22-35 LUTHER BURBANK SOUTH SHORELINE RESTORATION PROJECT

RFB ADDENDUM NO. 2

Issued November 30, 2022

7 ANCHORED LARGE WOODY DEBRIS
SCALE: NOT TO SCALE

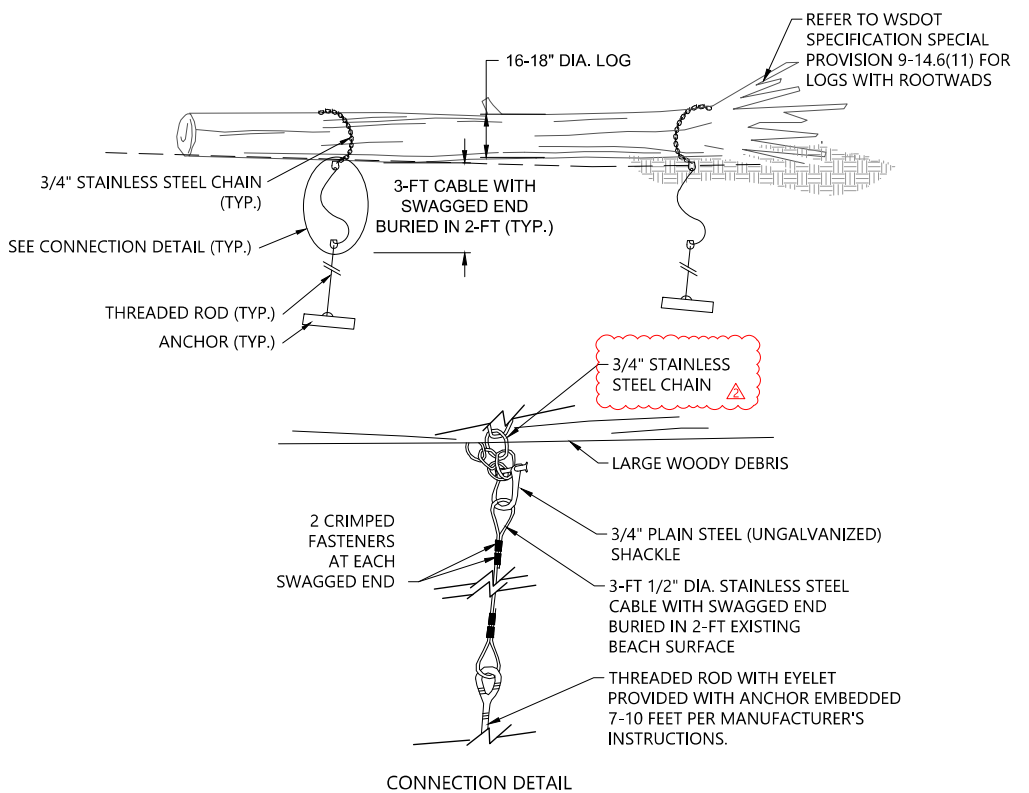
- A. Chain shall be 3/4 -inch stainless plain steel (~~ungalvanized~~) ~~lashing~~ chain.

Drawing	Revision
D-3	Detail 5 Chainlink Construction Fencing
CM-4	Detail 7 Anchored Large Woody Debris
